Product Change Description

[ZTE A2017U]

[Project Number:16ZTE027]

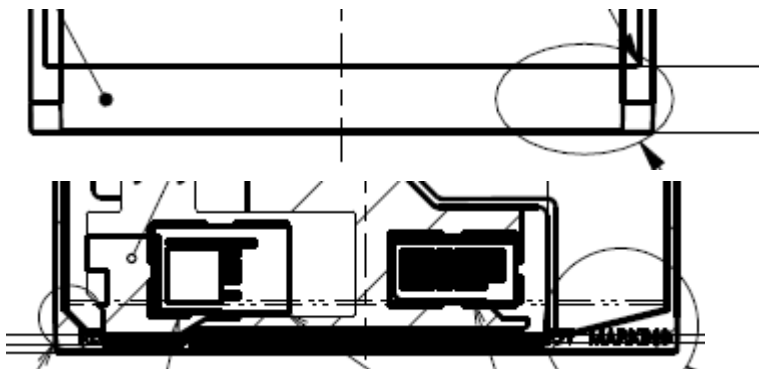
Antenna changes: GPS/WiFi/Bluetooth 3in1 antenna is now updated.

Aiming at improving GPS performance, we updated this antenna and this result to 1dB efficiency better than previous one. Meanwhile, WiFi/Bluetooth efficiency was slightly down.

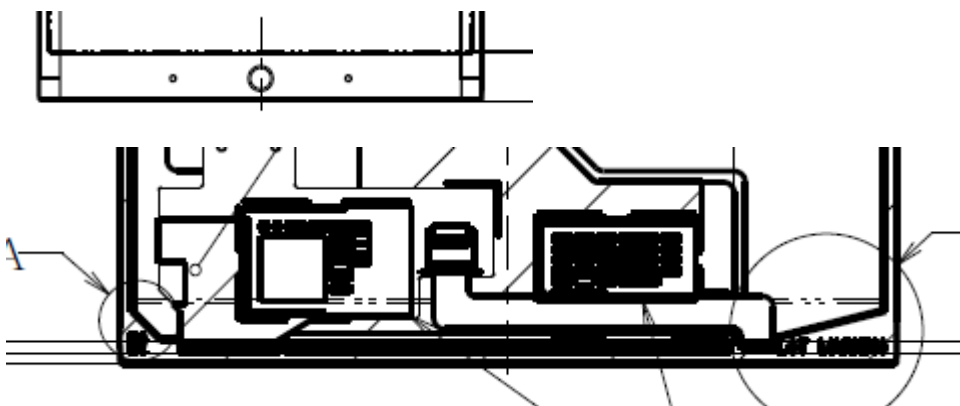
LCD changes: Yes, Added touch key and touch key FPC
